# OIL CONSERVATION COMMISSION AZTEC DISTRICT

RE: Horseshoe Gallup Pressure Maintenance Project No.2

Subject: Navajo leases 14-20-603-65, 14-20-603-2033, 14-20-603-2034,

Horseshoe Gallup Field, San Juan County, New Mexico.

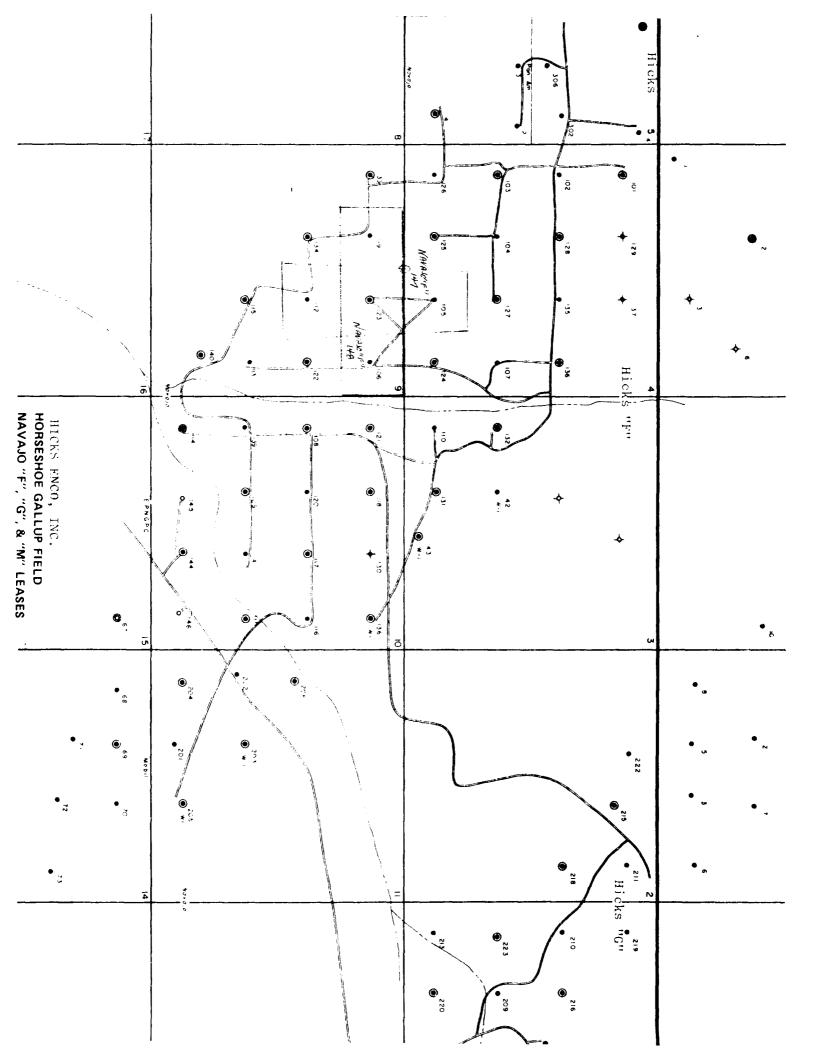
We have examined the plat submitted with your letter, and this is to advise you that the proposal is acceptable to this office. It would be our thought, however, that if the drilling of these pilot wells encounters high quality unswept ray sand, as you anticipate, that it may be advisable to produce these wells for a period of time, and then convert them to injection wells at a later date.

Your applications to drill the pilot wells should be filed with this office on form 9-331C, together with all of the supplemental data required by NTL-6.
